# BAYSIDE COUNCIL

## Planning Assessment Report

Application Details	
Panel Reference:	PPSSEC-21
DA Number:	DA-2019/386
Date of Receipt:	25/10/2019
Property:	128 Bunnerong Road & 120 Banks Avenue, Eastgardens
Owner:	
Applicant:	Mr Walter Gordon
Applicant Address:	Level 11, 528 Kent Street, Sydney
Proposal:	BATA 2 - Integrated Development and Staged Concept Development - land subdivision; building envelopes / height / setbacks for 13 buildings of between 2 and 20 storeys to accommodate a variety of residential dwellings and a minimum of 5,000m <sup>2</sup> of non-residential land uses including child care centres, supermarket and other commercial uses; landscaping and public domain works; proposed road layout; basement and podium level car parking; and car parking rates; resulting in a total floor space ratio of 2.35:1
Recommendation:	Approval subject to Conditions
Value:	\$786,422,691.00
No. of submissions:	Five (5)
Author:	Fiona Prodromou - Senior Assessment Planner

Date of Report:	November 2020

##### a) Lots B & E

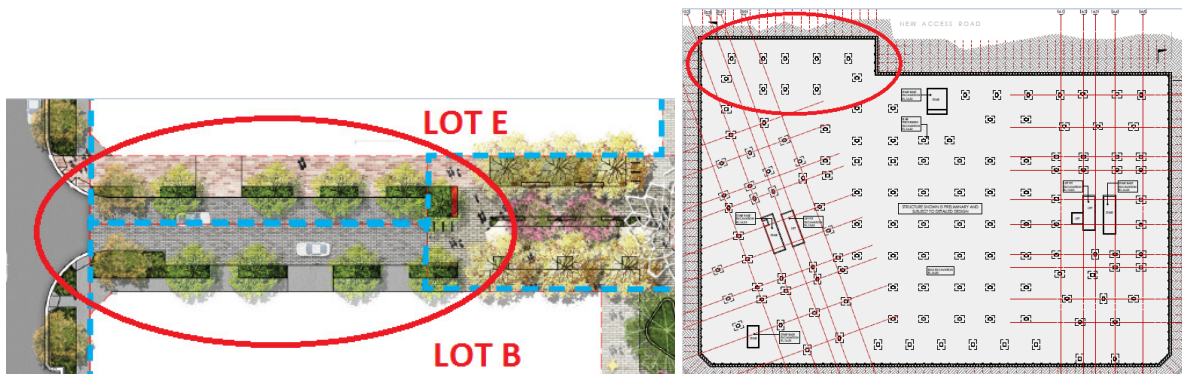
- i) Lot E - Excavation should not extend into the 4m northern and 3m southern / western setbacks of Lot E, in order to ensure sufficient future deep soil provision as required by the ADG is somewhat achievable on this lot, post

dedication of the adjoining eastern open space and establishment of new lot boundaries.

Excavation is sought to extend beyond the proposed building footprint into the spur road between lots B & E, circled in red below. In order to facilitate appropriate soil depth / volume for the planting of street trees on both sides of the spur road, as depicted within the Landscape Stage 1 Concept Plan Report the proposal has been conditioned to require tree wells or alternative design measures to facilitate the longevity of street trees within the public domain.

- a) Basement levels are limited to beneath building footprints.
- b) All building setback areas depicted in blue, on the site setbacks plan prepared by SJB Architects, with the exception of the 3m setback to the west of Lot J, be provided as deep soil zones.
- c) Hard surfacing within deep soil zones is minimised.
- d) Tree wells or alternative design measures to facilitate the longevity of street trees within the public domain are required.

b) Lots A & D

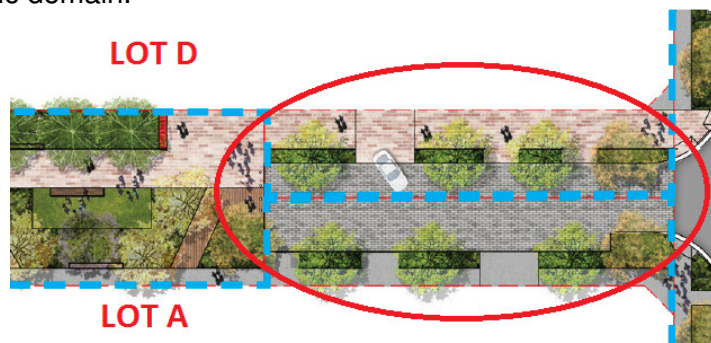
Akin to arguments presented in (a) above, where future basement excavation is proposed beneath spur roads identified below between lots A & D, there is likely to be insufficient depth and soil volume to facilitate the growth of large street trees internally on site. It is reiterated that the proposal has been conditioned to require tree wells or alternative design measures to facilitate the longevity of street trees within the public domain.

Additionally, should future basement excavation for Lots A & D extend to the western boundary of the site to Banks Avenue, beneath the proposed 6m building setback, depicted in the site setback plan below, it will not be possible to ensure appropriately sized trees are delivered within the front building setback to Banks Avenue in order to provide an appropriate buffer to soften building forms which are anticipated to be 19 & 20 storeys in height from the public domain.

d) Lots C & F

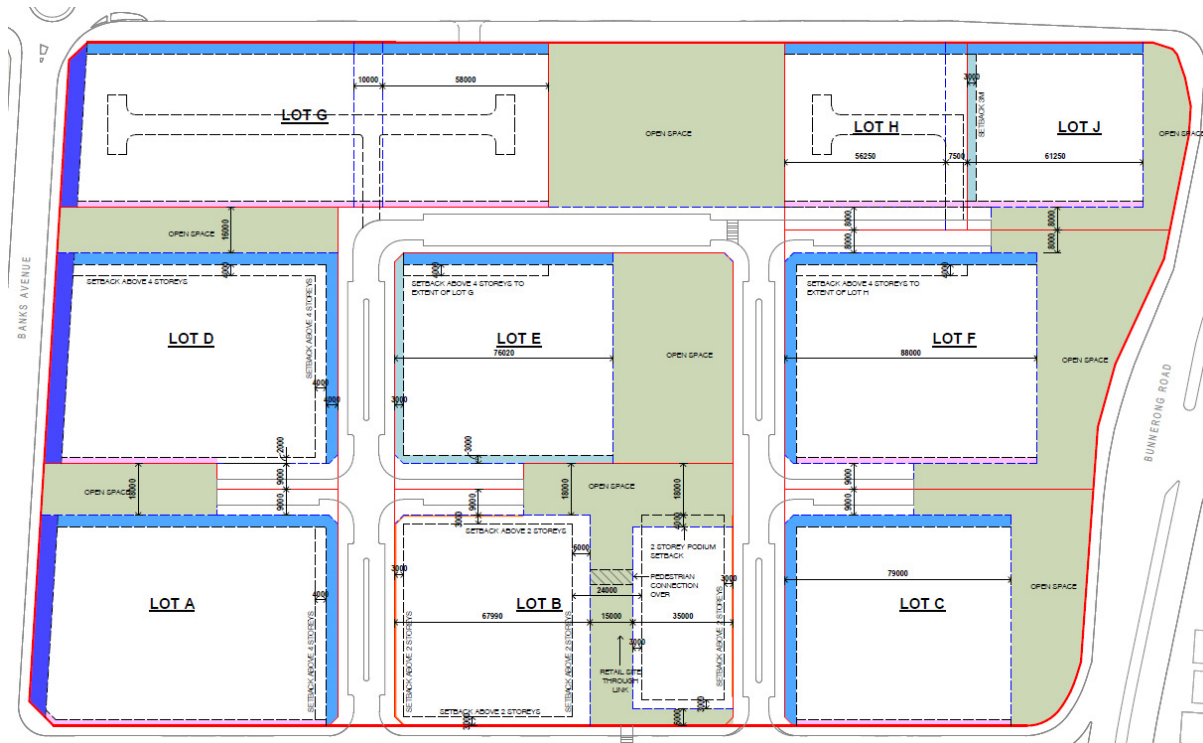
Discussion referred to above with respect of excavation beneath spur roads is reiterated with respect of the spur road between Lots C & F.

Additionally, the extension of a basement footprint to the new northern and western boundaries of Lots C & F will minimise the ability for growth & longevity of street trees internally within the site.

Excavation should not extend into the northern and western setbacks of Lot C & F, in order to ensure future deep soil provision as required by the ADG is in some way achieved on these lots, post dedication of the adjoining eastern open space areas and establishment of new lot boundaries.
